Technical Service Bulletin: TSB150134

New Cylinder Head Gasket Part Numbers

Figure 1, Block Dimension Measurement Locations

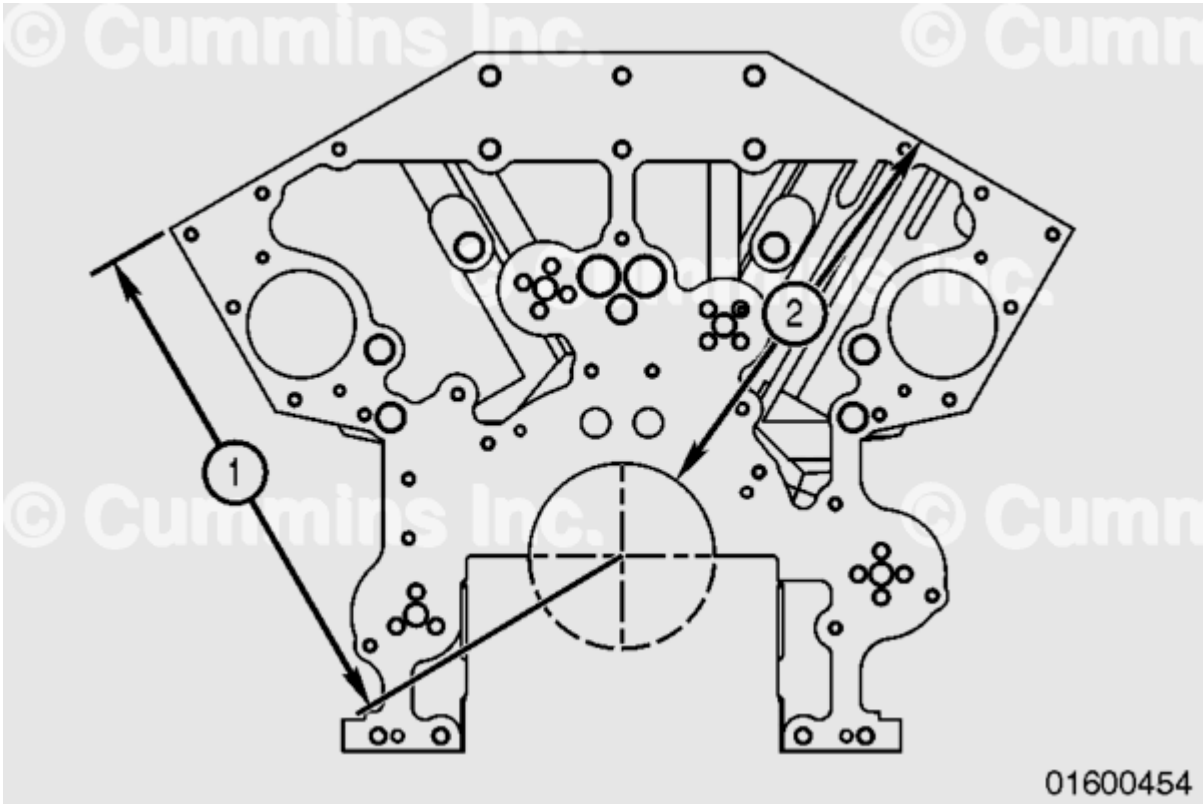
To maintain proper engine operation, oversize cylinder head gaskets are needed for blocks which have the top surface or deck machined during overhaul.

The following dimensions **must** be measured to determine the correct oversized cylinder head gasket to be used:

- Block deck to crankshaft centerline (1)
- Block deck to crankshaft bore (2).

See the corresponding Service Manual for more information. Reference Procedure 001-026 in Section 01.
